# CITY OF ALBUQUERQUE

**Re: Rexel**  
**5300 Eagle Rock NE**  
**30-Day Temporary Certificate of Occupancy**  
**Transportation Development Final Inspection**  
Engineer's/Architect's Stamp dated 4-1-19 (C18D037C)  
Certification dated 10-07-19

1 Site Plan - TCL Proposed  
 Scale: 1" = 30'-0"

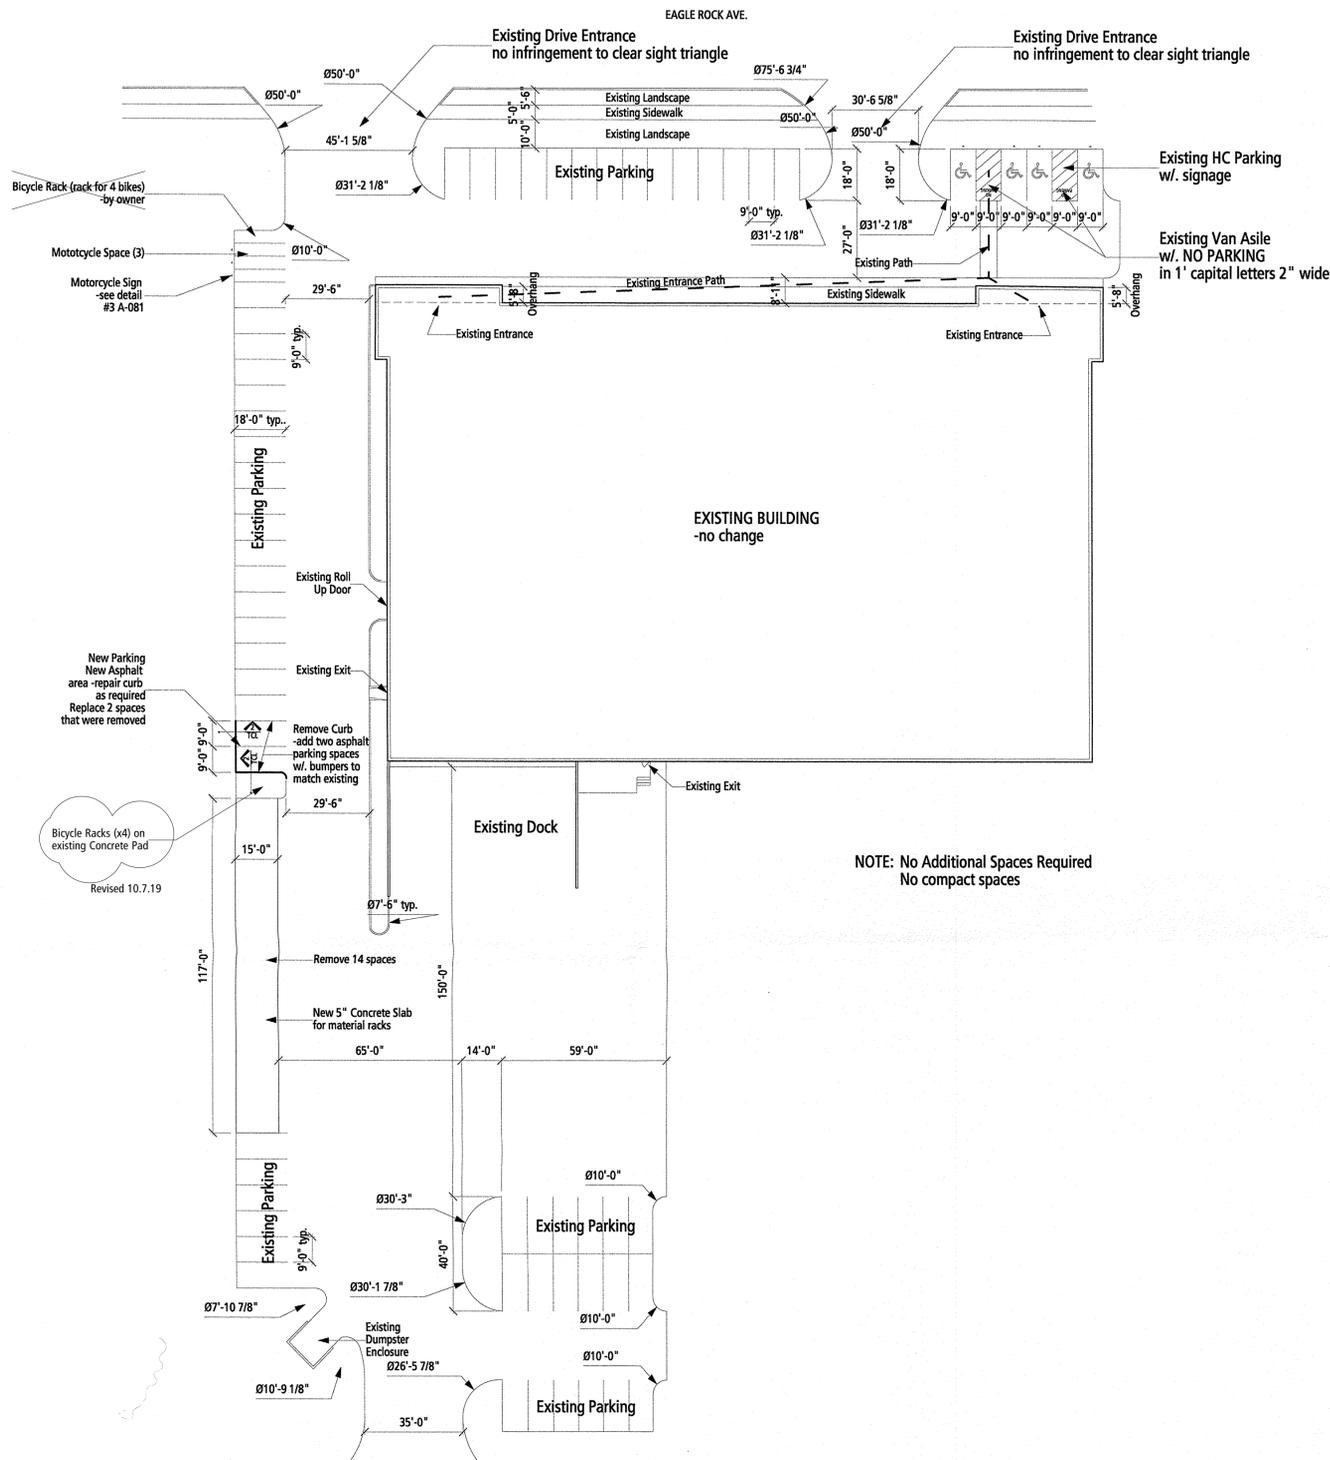
- Motorcycle parking spaces shall be designated by its own conspicuously posted upright sign, either free-standing or wall mounted per the zoning code. (Each stall requires its own individual sign)
- Please relocate bike racks. Picnic table blocking required clearance. (See attached bike rack details.)

THE BIKE RACKS RELOCATED SOUTH APPROXIMATELY 130' TO EXISTING CONCRETE PAD.
